S4.55 CHANGES

CLIENT: ANGLICARE CASTLE HILL
ADDRESS: 284 CASTLE HILL RD, CASTLE HILL NSW 2154
DRAWING: EXISTING & DEMOLITION PLAN WEST

PROJECT
201656 WESTERN ROAD

CLIENT
ANGLICARE CASTLE HILL
ADDRESS
284 CASTLE HILL RD,
CASTLE HILL NSW 2154
DRAWING
ELEVATIONS - BUILDING 8

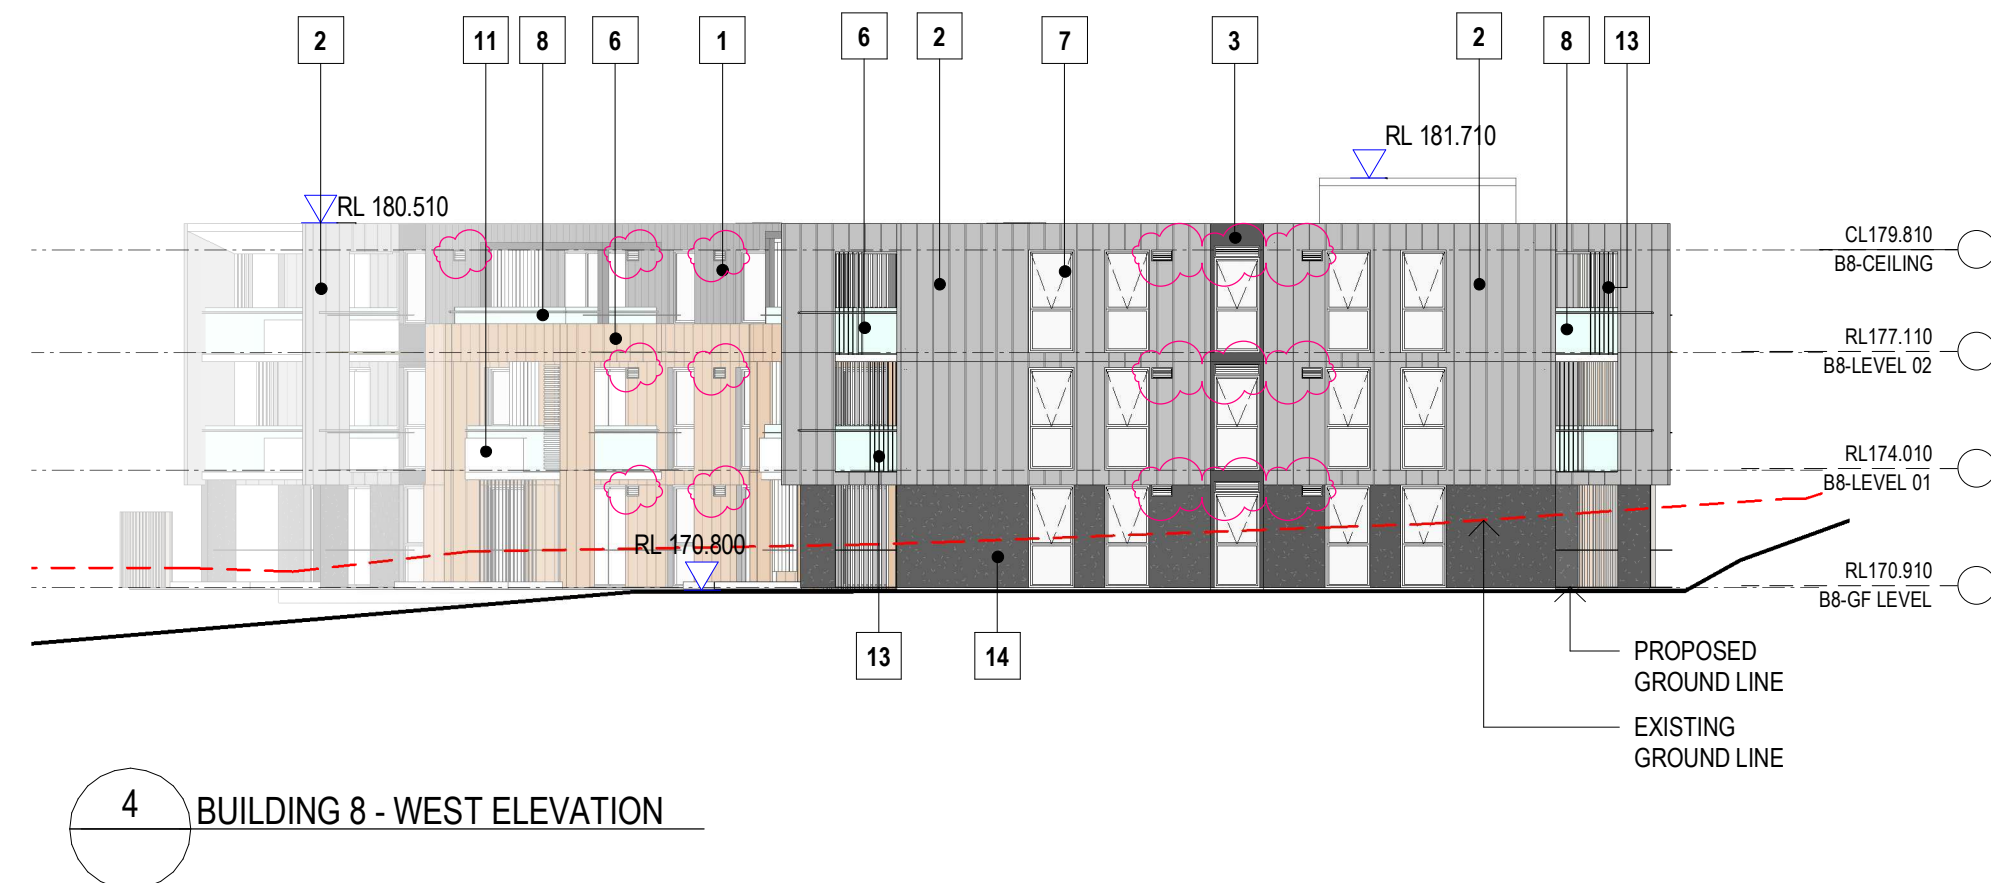
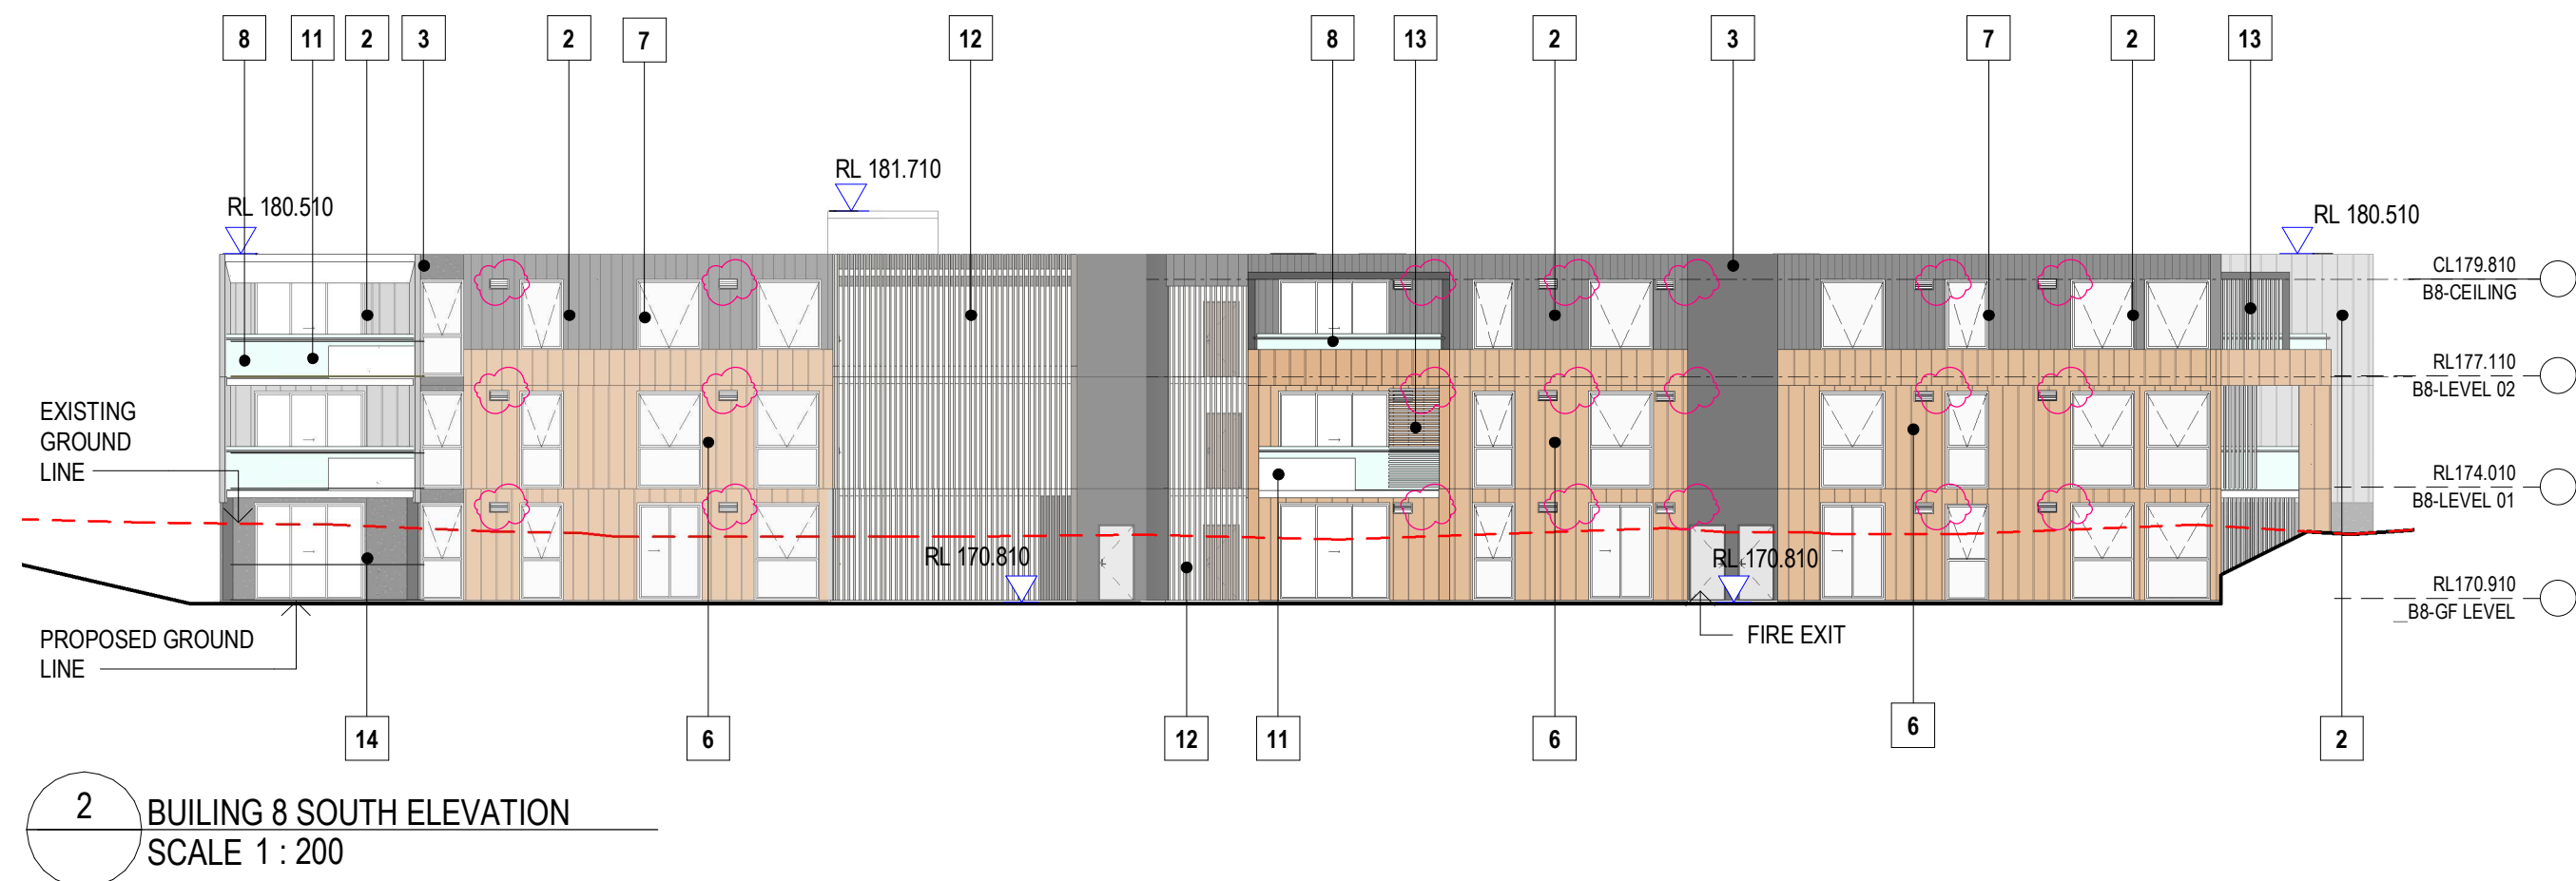
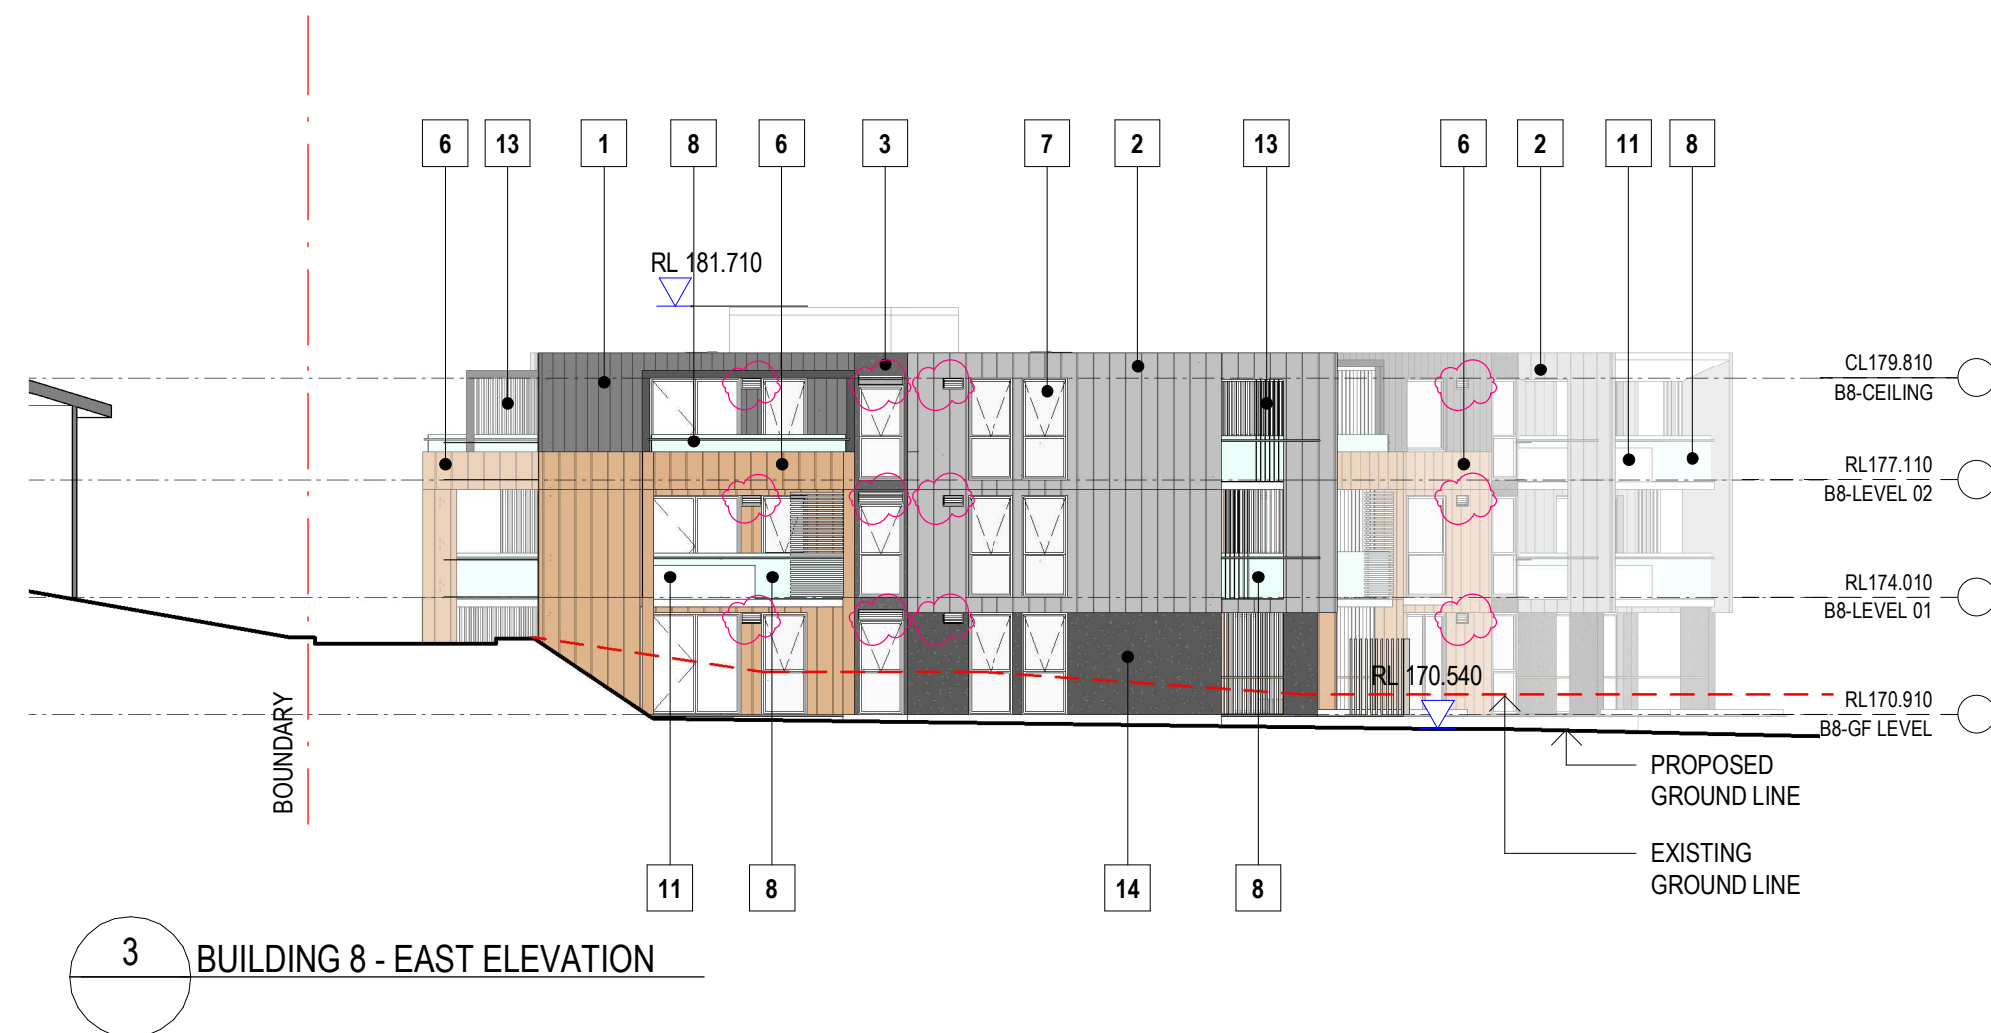
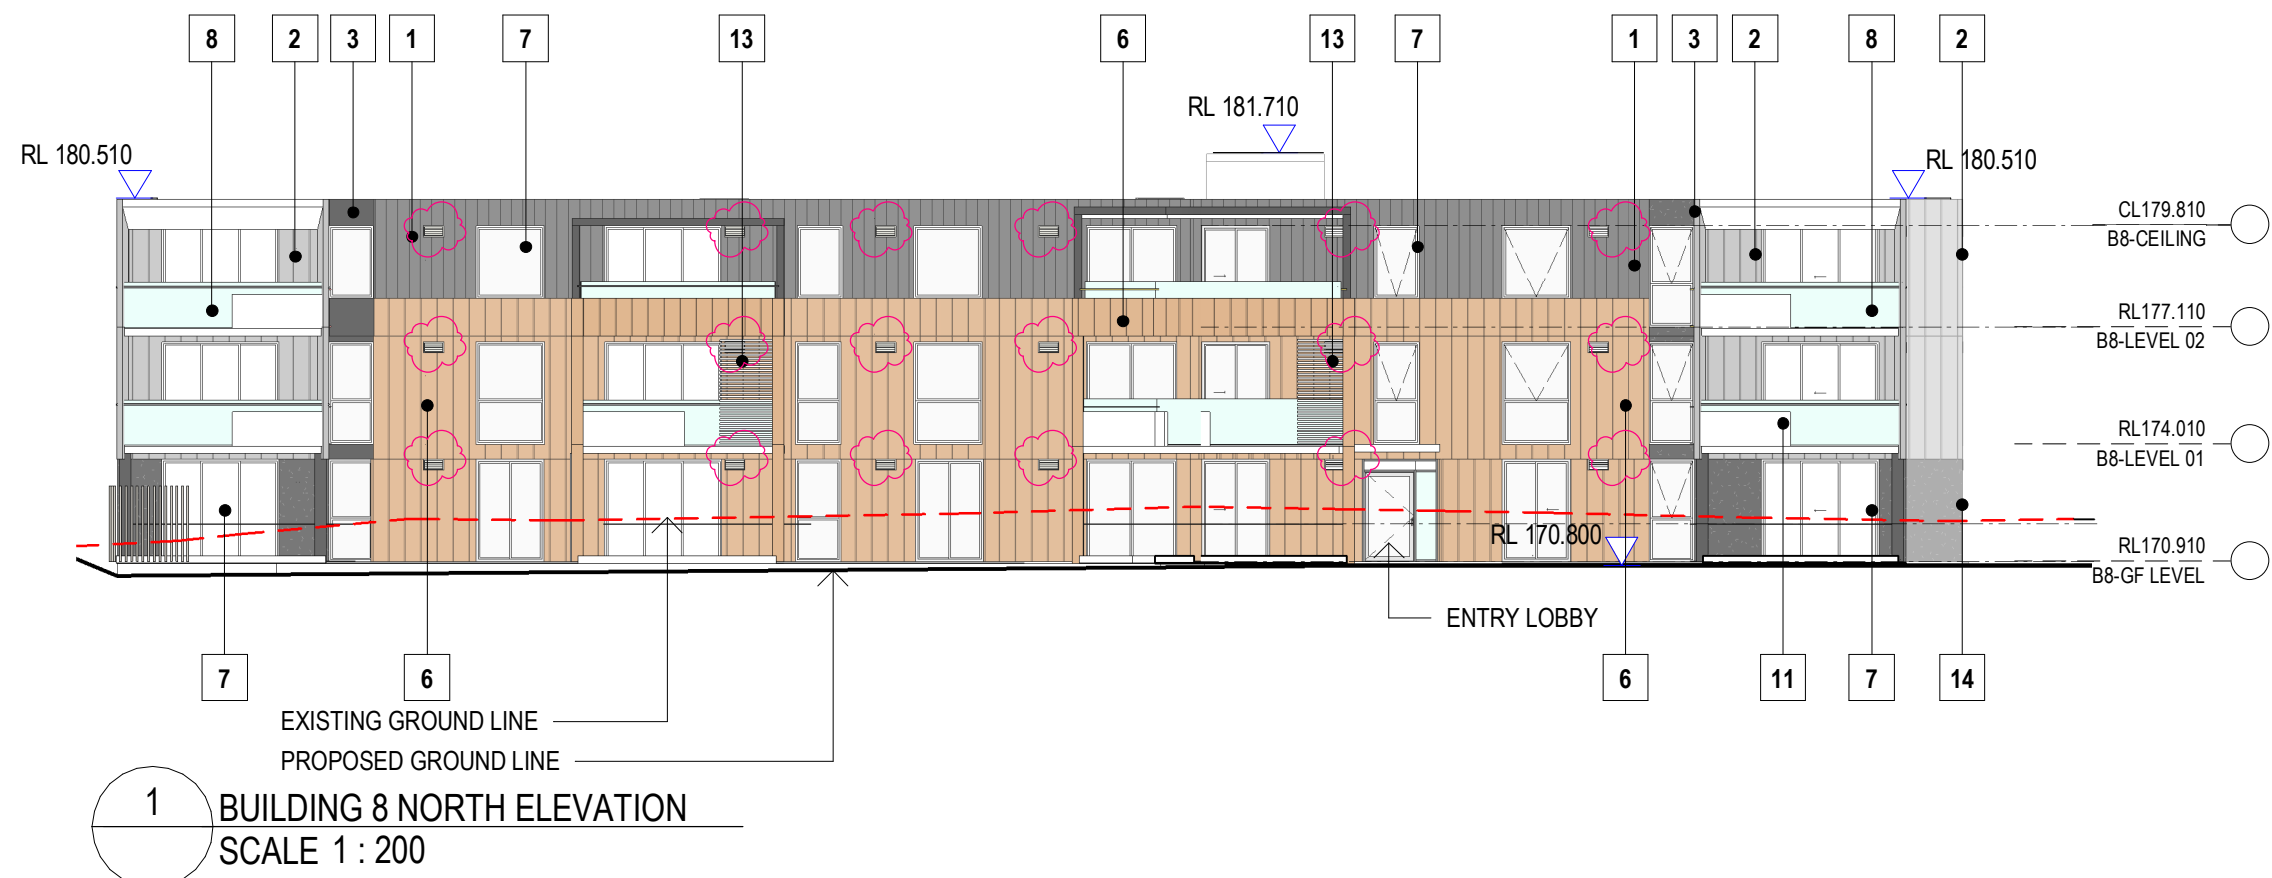
- MECHANICAL LOUVRES ADDED
